DESCRIPTIVE REPORT

Type of Survey Photogrammetric Shoreline

Field No. \_\_\_\_\_ Office No. T-8781  
PH-7(46)C

Locality Mad Horse Creek to Dunks Point

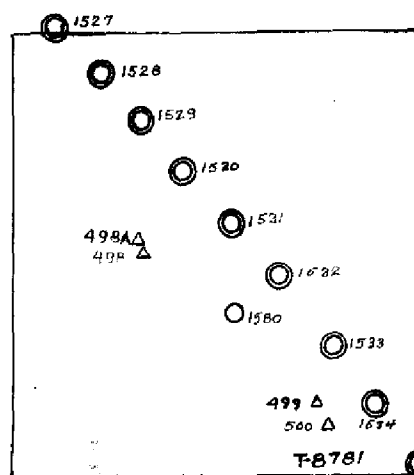
11. An additional flight of photographs, paralleling and overlapping the flight that was taken would have been desirable.
12. A few more identifiable control stations, especially at the southern end of radial plot would also have been desirable.
13. The selection and identification of substitute stations and the identification of the horizontal control stations was very good.
